CORRESPONDENCE FORMAppeal No: ABP -310466-21

Further Development of a Quarry**Application under Section 37L of the Planning and Development Act 2000, as amended.****Laurence Behan, Windmill Hill, Rathcoole, Co. Dublin**

I refer to the above and to your letter of 24th February 2023 requesting a response, where the applicant is so minded, under Section 131 of the Planning and Development Act 2000, as amended, to a number of observations received from third parties.

Figure 1: Location and distance between the nearest part of the subject quarry and the end of the nearest runway at Casement Aerodrome

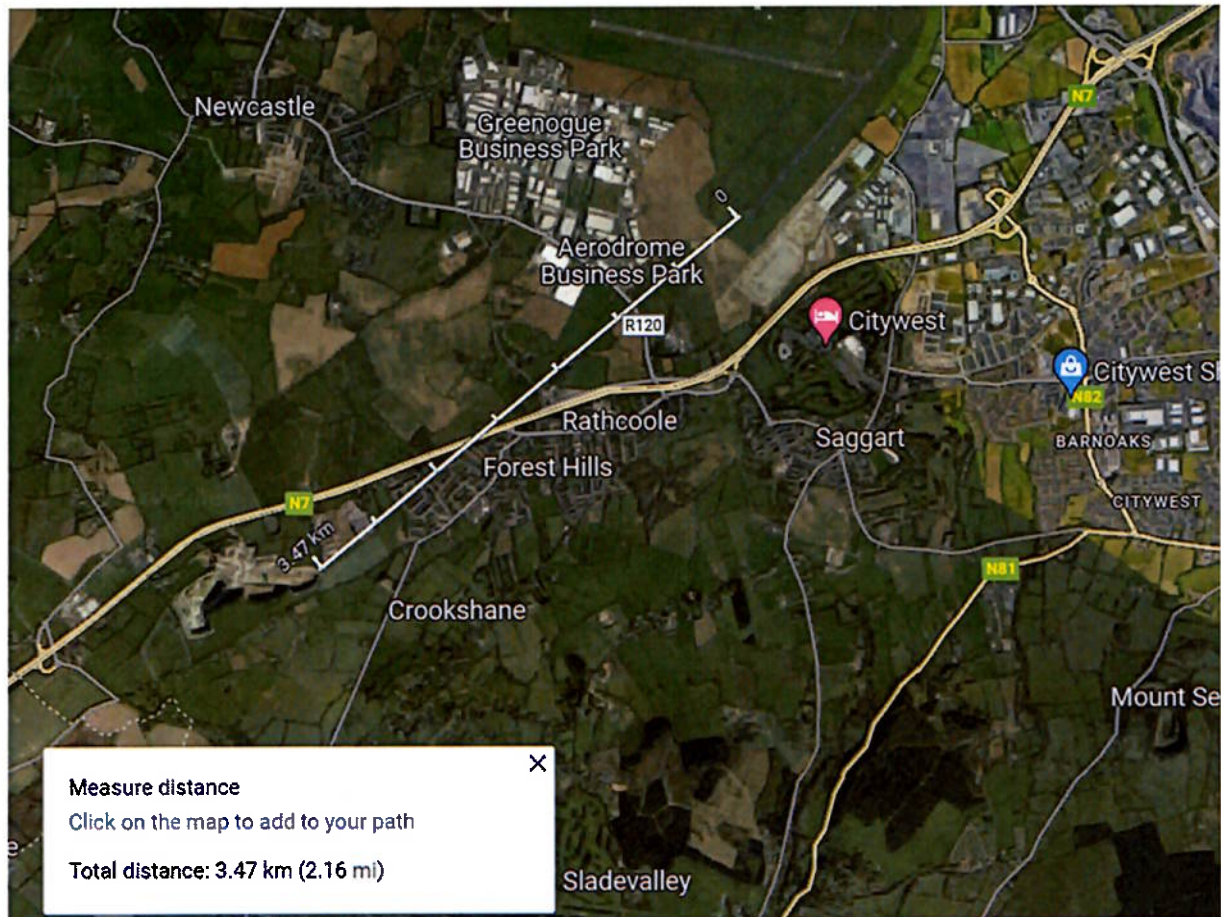
The aerodrome in question is located some 3.47km from the end of the runway nearest the quarry in question to the nearest point of the quarry. This is considered a relatively substantial distance away. Figure 1 below shows the respective locations and the measures distance as the crow or plane flies from one to the other.

It should also be clear from Figure 1 above that the quarry the subject of this S37L application is not located on the direct flight path of either of the only 2 no. runways at the aerodrome. We would therefore contest the expressed view of the Department that the subject quarry is in any way proximate to the aerodrome or either of its runways, even the nearest one to the quarry the subject of our client's application to the Board.

As can be seen from Figure 1 above, more directly aligned with the direction of the run way is the village of Rathcoole and the intervening housing estate at Forest Hills.

View 1 - Opposite the existing quarry entrance.

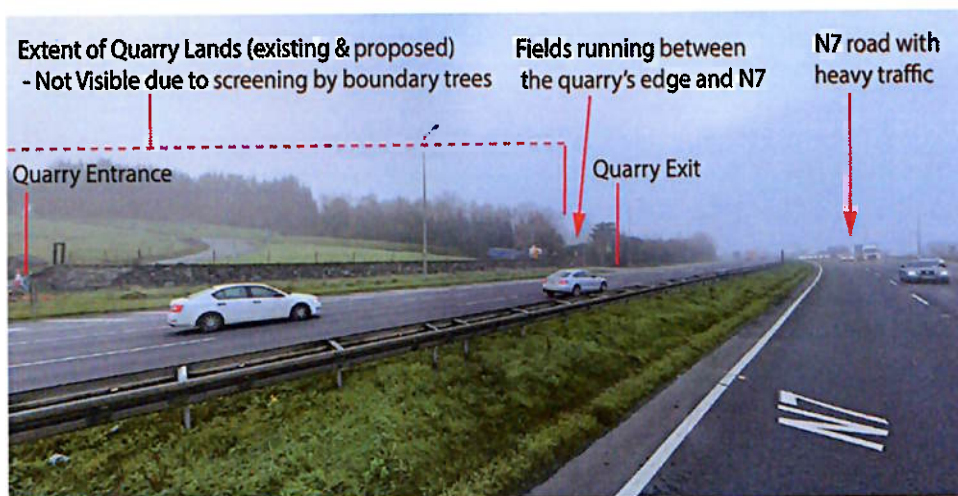
Due to road safety, it is not possible to undertake a photomontage from the N7, as requested, which is a busy national route. This is evident in the photographs below. However, as a reasonable alternative the following images have been annotated.

The existing trees and hedgerows screen views of the quarry and the proposed extension lands, with only the traffic on/off the quarry's entrance and exit visible. The image also shows how busy the road is with traffic.
